DEVELOPMENT REVIEW COMMITTEE (DRC) COMMENT REPORT

PROJECT NAME: Aloft Hotel

CASE NUMBER: PLN-SITE-20070017

REQUEST: Site Plan Level III Review: 138-Room Hotel with
Associated Parking Reduction

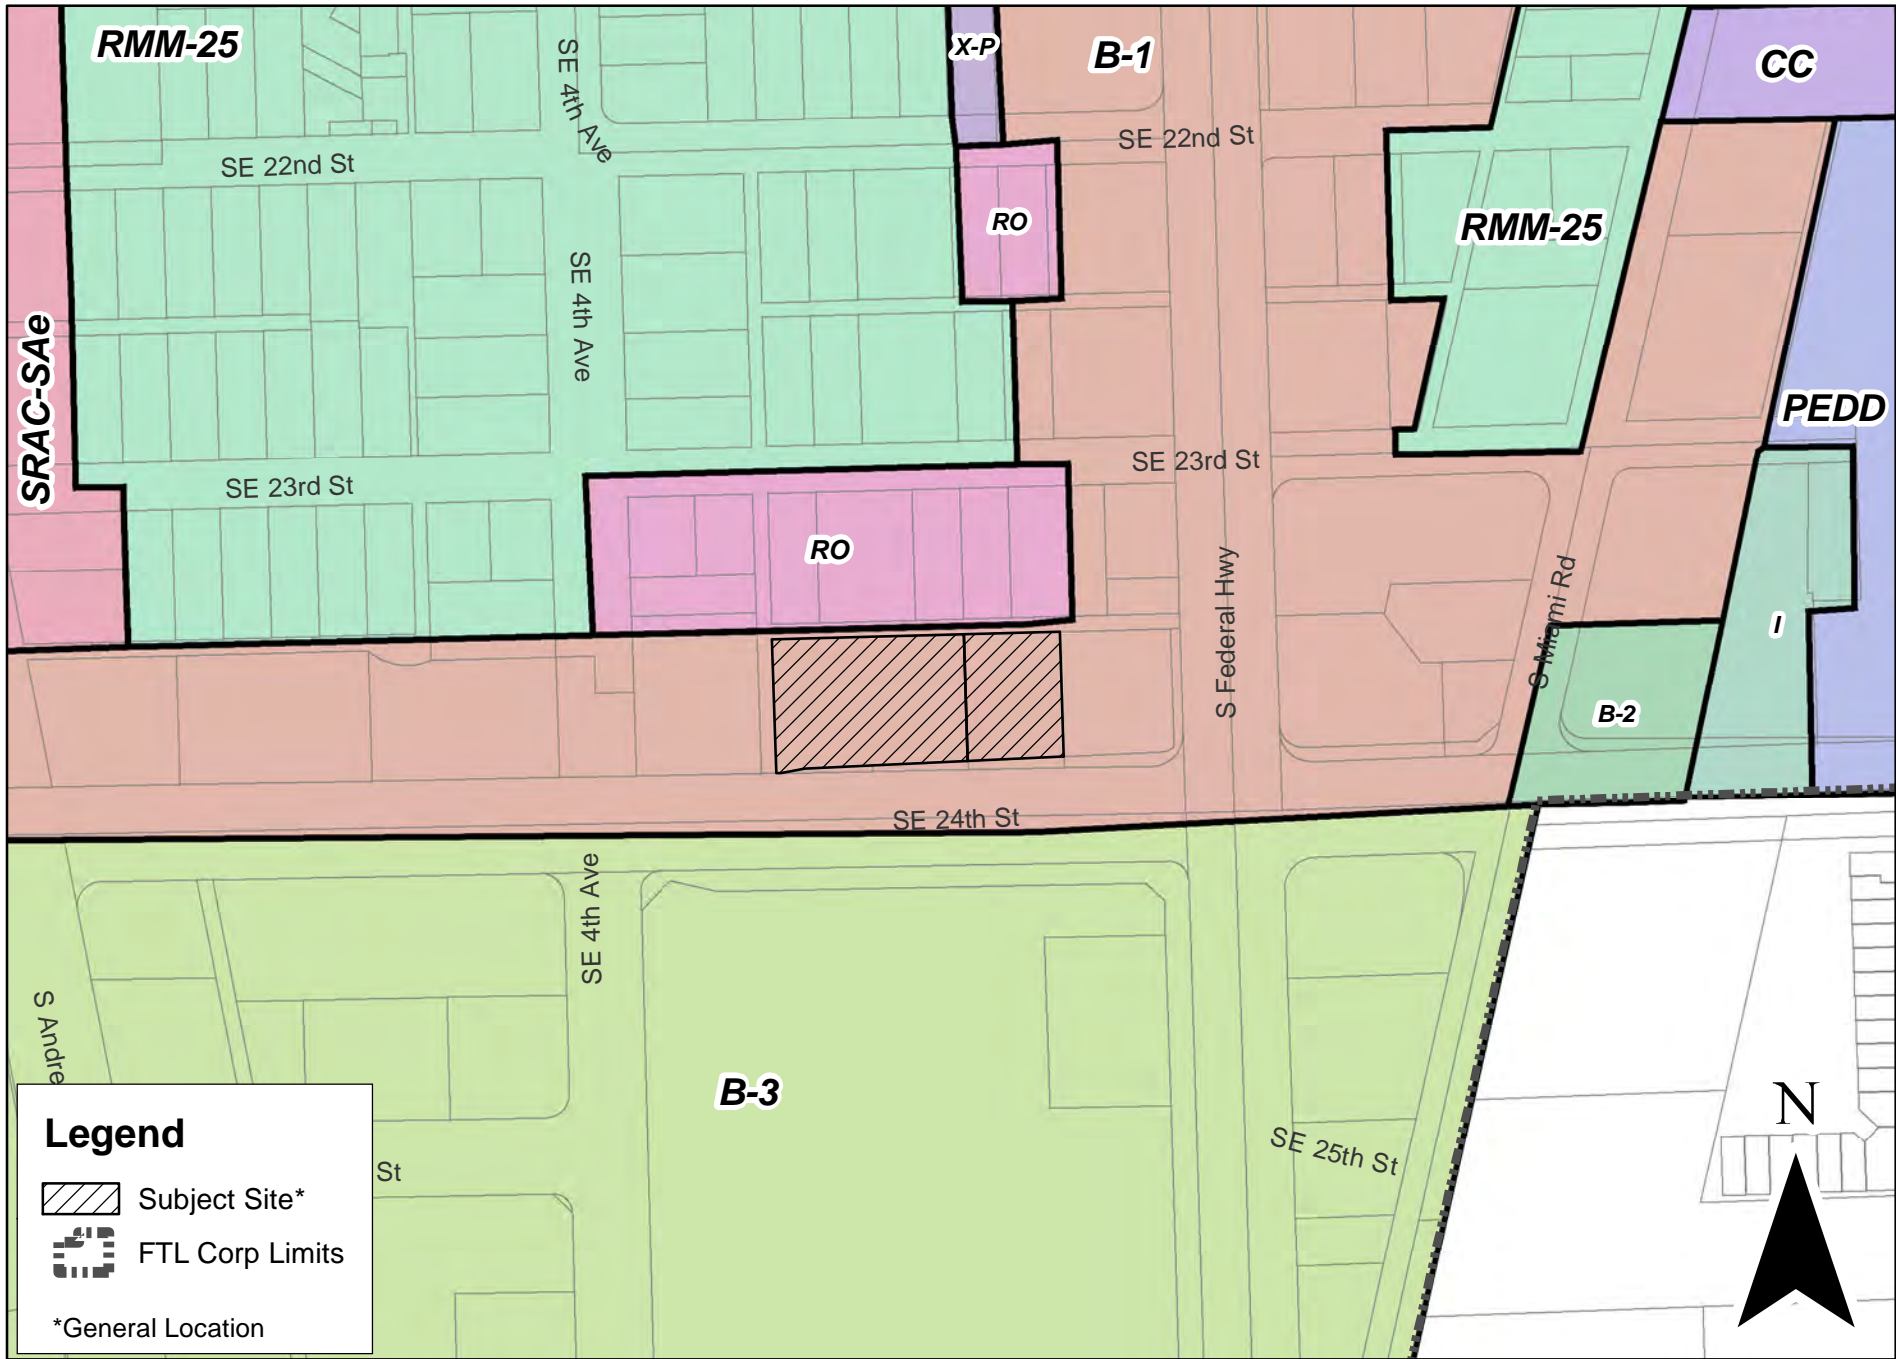
- 14) Provide legible photometric plan for the entire site. Extend values on photometric plans to all property lines. Provide lighting fixture details on photometric plan. Indicate lighting poles on site plan and landscape plan and provide detail with dimensions. Light poles appear within the parking stalls, please clarify on plans. Consider reduced height of poles due to proximity of the project nearby residential area. Be aware that lighting fixtures greater than ten (10) feet in height are used, they shall be located a minimum of fifteen (15) feet away from shade trees (Sec. 47-20.14).
